UNITED STATES
NUCLEAR REGULATORY COMMISSION
WASHINGTON, D. C. 20555

INDIAN POINT STATION UNIT NO. 3

AMENDMENT TO FACILITY OPERATING LICENSE

Amendment No. 32
License No. DPR-64

FIGURE 6.2-1
MANAGEMENT ORGANIZATION CHART
INDIAN POINT 3 NUCLEAR POWER PLANT

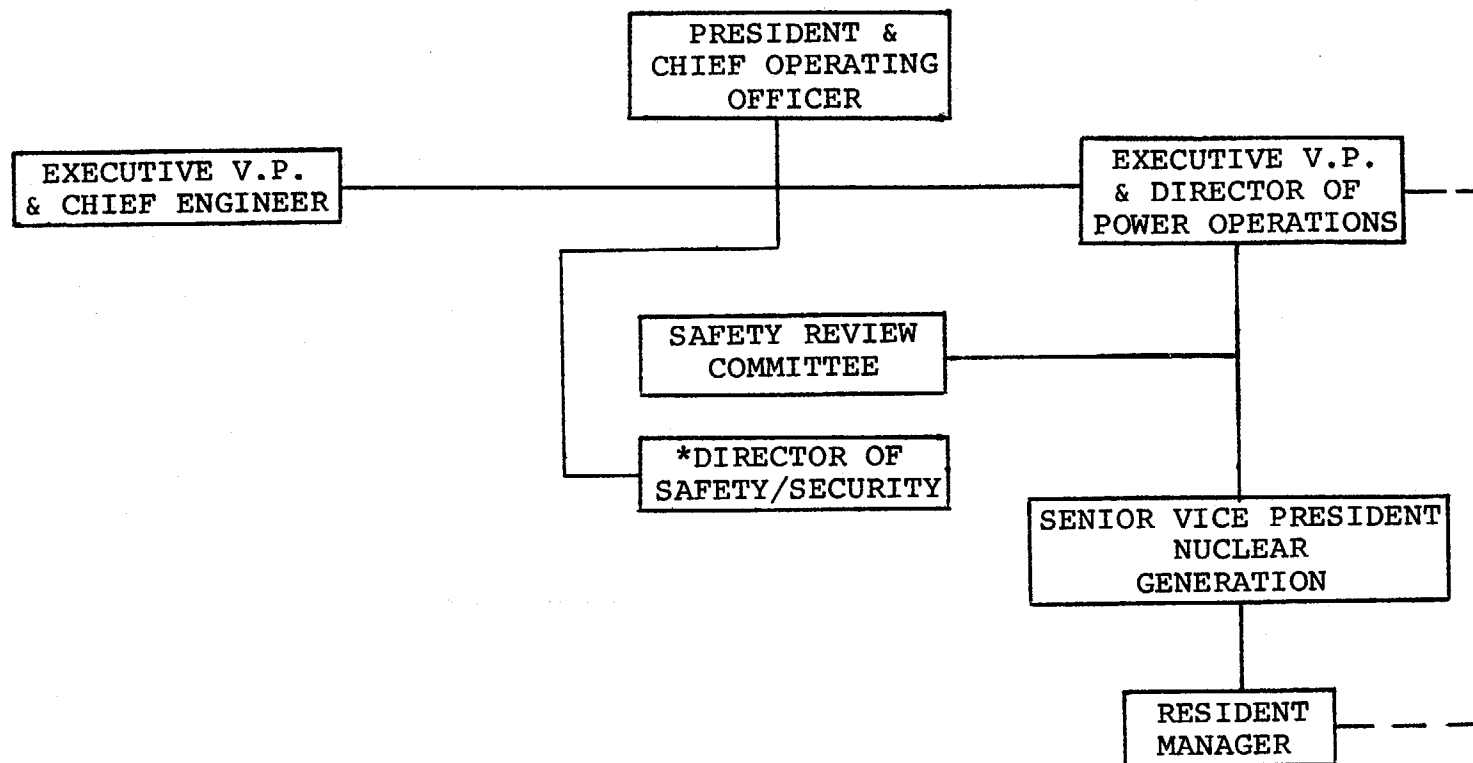
The proposed change to the organization chart has the Resident Managers reporting administratively to the Executive Vice President and Director of Operations instead of to the General Manager and Chief Engineer. Since the Executive Vice President and Director of Power Operations reports directly to the President and Chief Operating Officer, the proposed change will strengthen the licensee's management of nuclear operations. We, therefore, find this change acceptable. We also find acceptable changes in position titles.
